Subject: Duke Energy Carolinas, LLC  
William States Lee III Nuclear Station - Docket Nos. 52-018 and 52-019  
AP1000 Combined License Application for the  
William States Lee III Nuclear Station Units 1 and 2  
Response to Request for Additional Information  
(RAI No. 2350)  
Ltr# WLG2010.08-02

**Lee Nuclear Station Response to Request for Additional Information (RAI)**

**RAI Letter No. 067**

**Reference NRC RAI Number(s): RAI 03.07.01-004**

Figure 16 - Lee Unit 1 - Northwest Corner Geologic Cross-Section U-U'

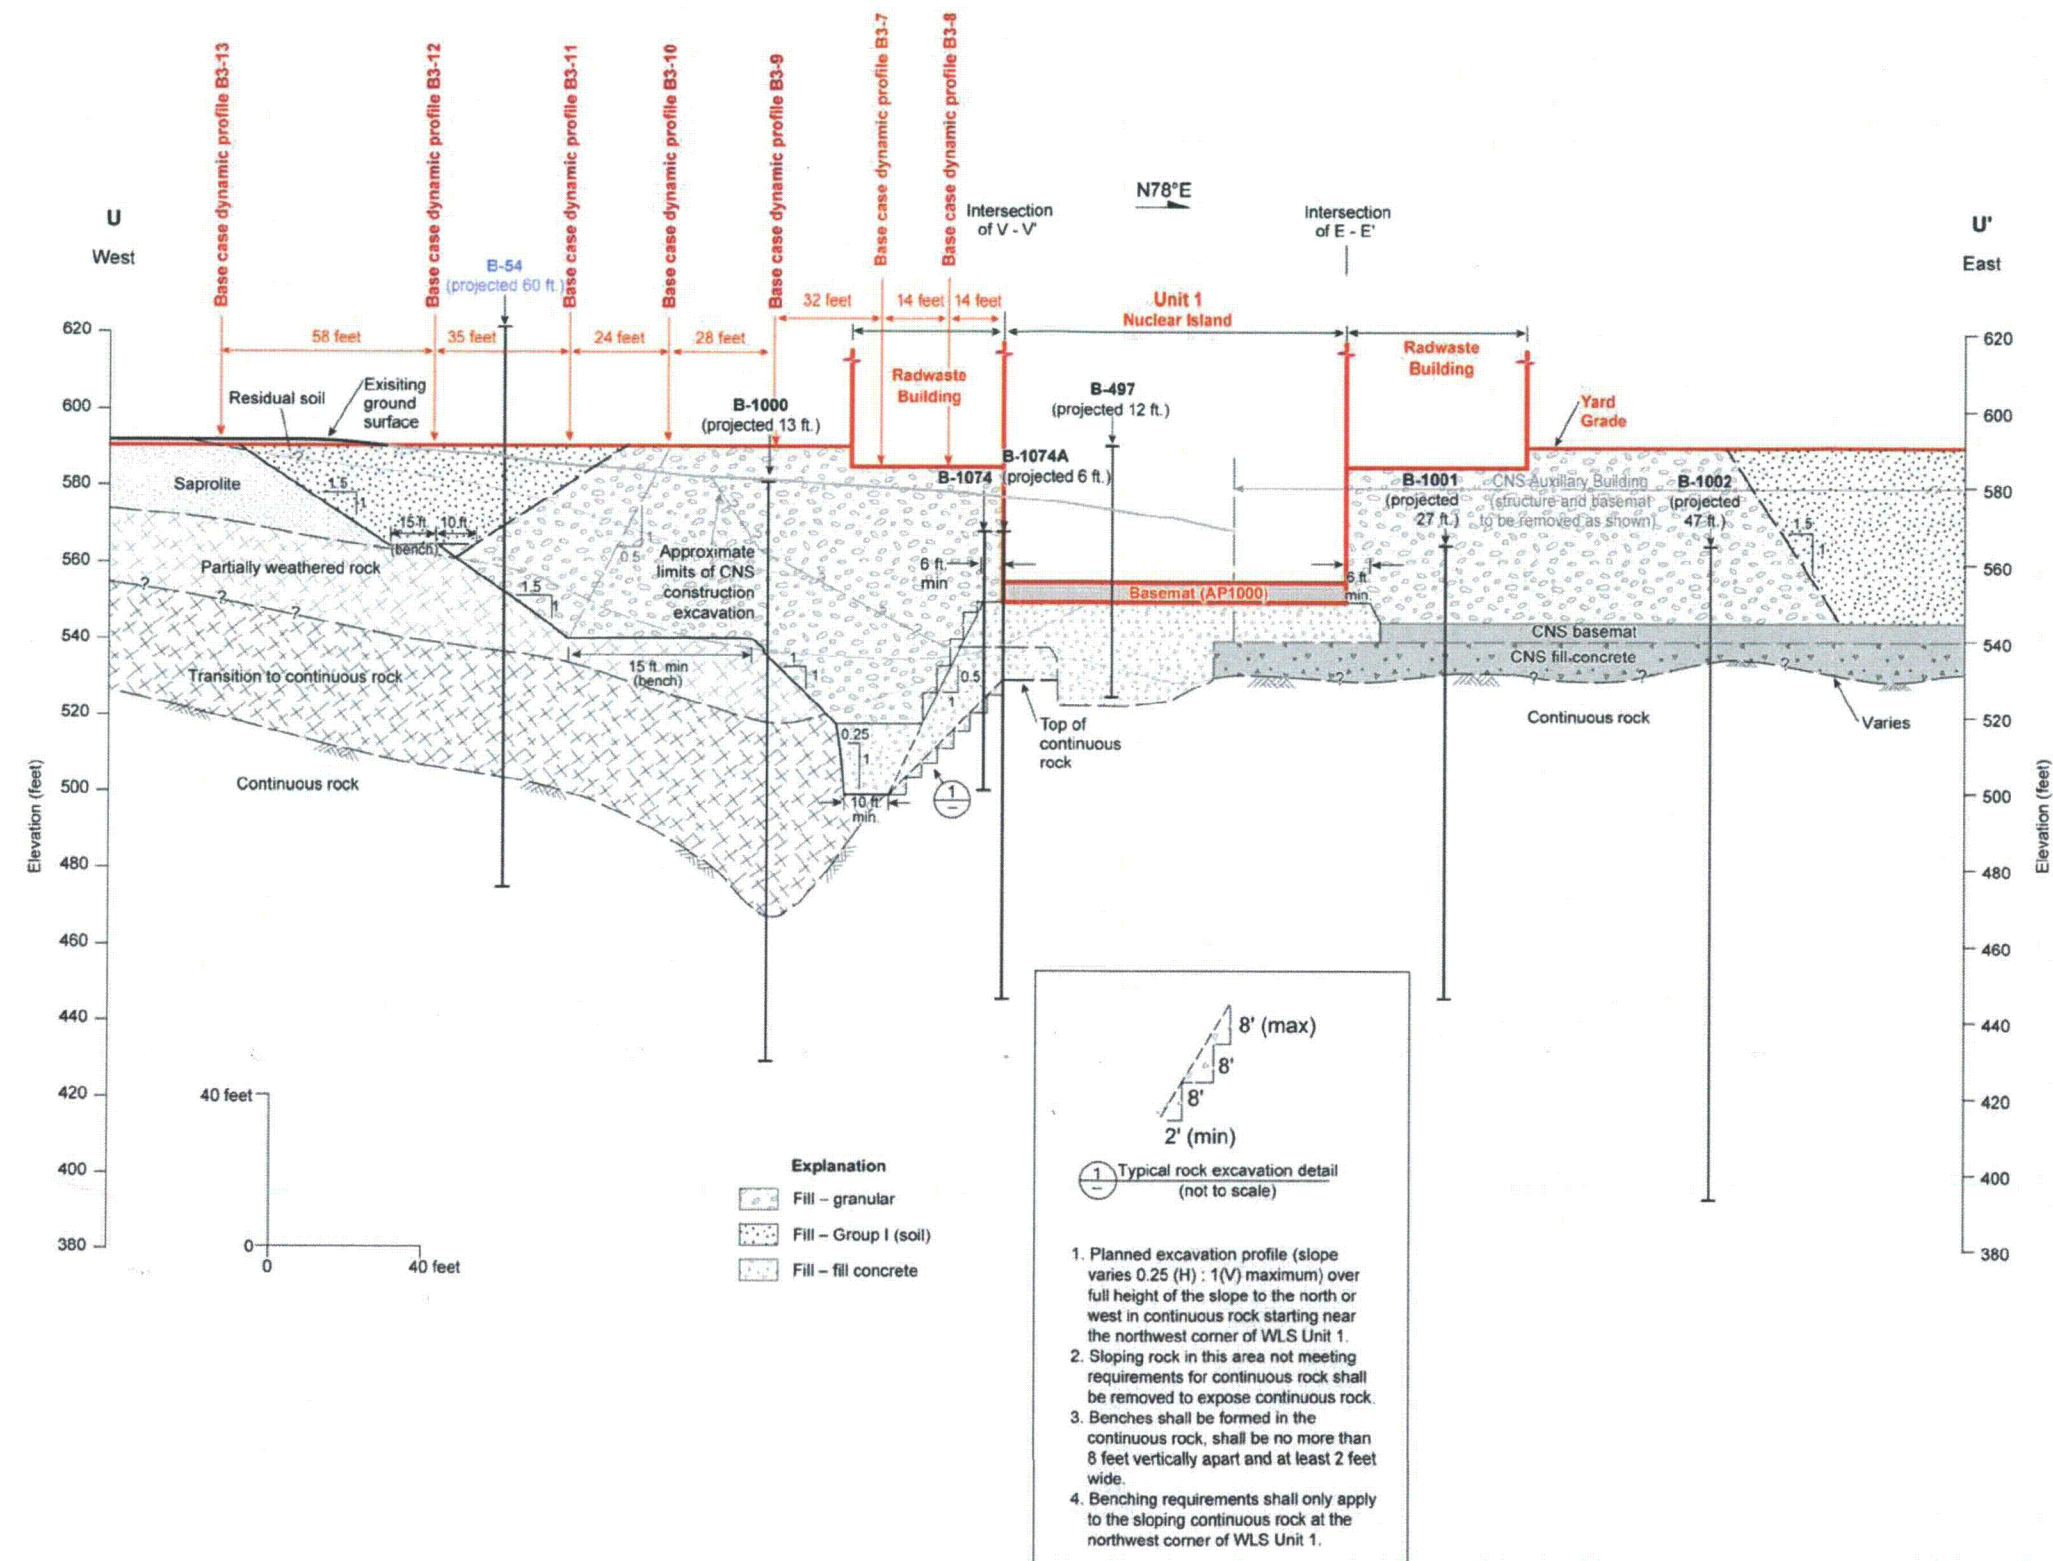
To ensure that the support conditions at the northernmost end of the Unit 1 Annex Building (Northwest Corner) do not result in unacceptable amplification of motions in that area, Duke Energy has also evaluated several profiles in that area. Figure 15 shows the location of these profiles, and Figure 16 illustrates the associated geologic cross-section, similar to that shown in FSAR Figure 2.5.4-245, and the location of the profiles. Profiles at locations B3-7, B3-8, and B3-9 are representative of the northern portion of the Unit 1 Annex Building support zone. These profiles are characterized by thicker layers of granular fill material than those investigated above, ranging from fifty to seventy feet thick. Figures 17, 18, and 19 illustrate typical profiles at these locations for one of the three granular fill materials considered and for one of the three groundwater levels considered at each location. Other profiles include features such as saprolite fill and Group I fill that are not characteristic of the material supporting the Annex Building.

Figure 22 - Lee Unit 1 - Northwest Corner Horizontal Foundation-Level Spectra Compared to Reference 3

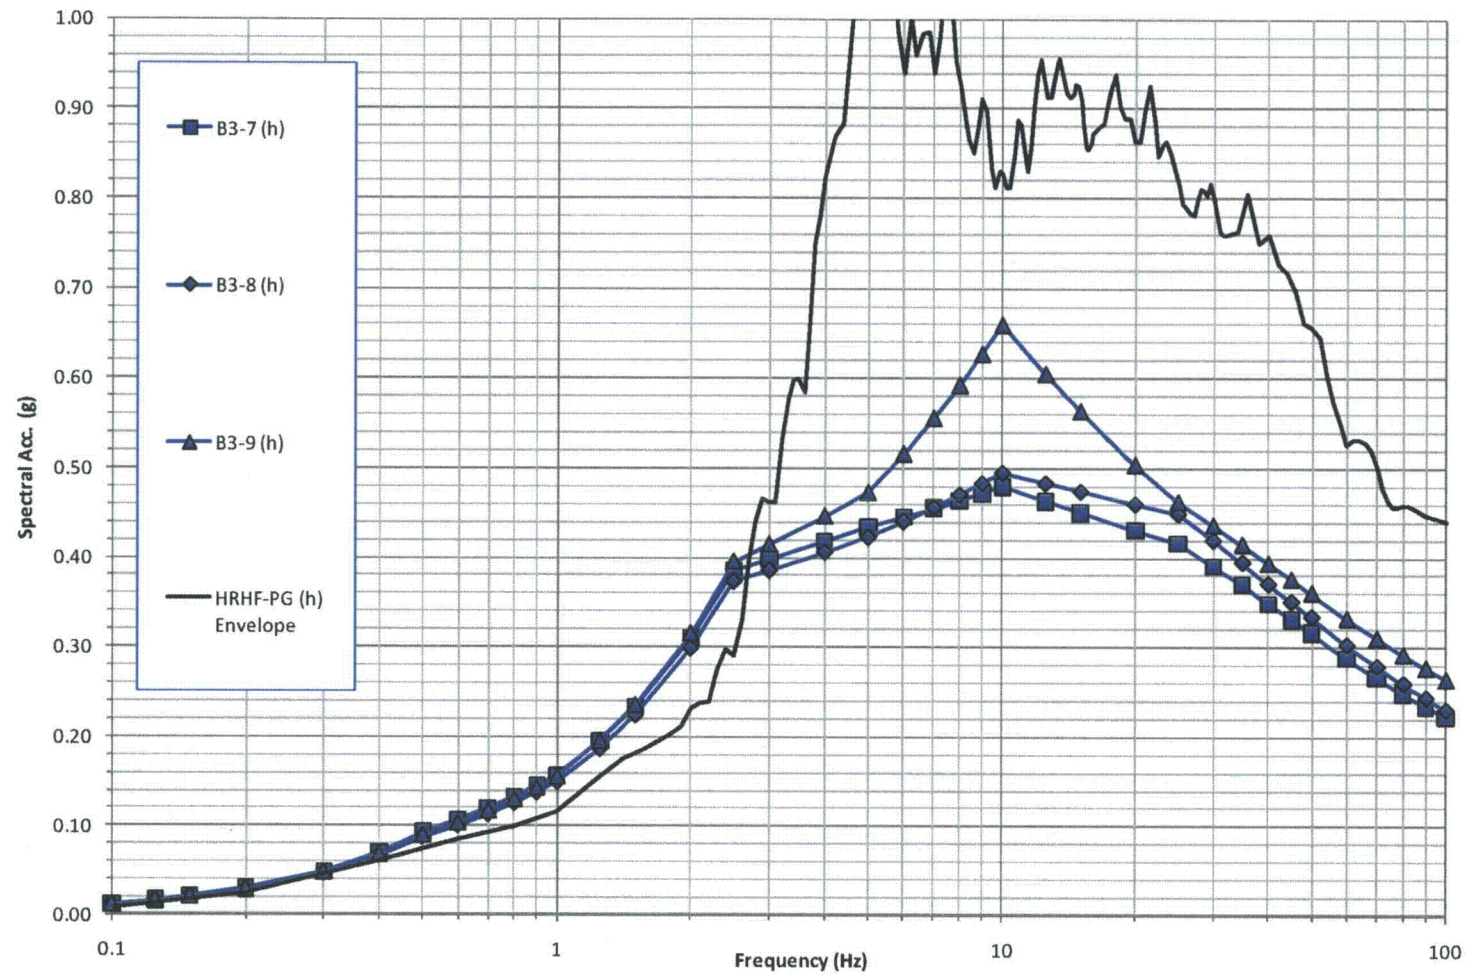
Figure 22 (horizontal) and Figure 23 (vertical) compare the calculated Unit 1 Northwest Corner foundation-level spectra to the HRHF-PG spectra considered in Reference 3. The comparison for the Northwest Corner locations is similar to that described for the initial six locations, except that there is less margin in the vertical direction at around 30 Hz. Figure 24 (horizontal) and Figure 25 (vertical) summarize the spectrum results for the nine locations described and permit direct comparison of the results for the various locations.
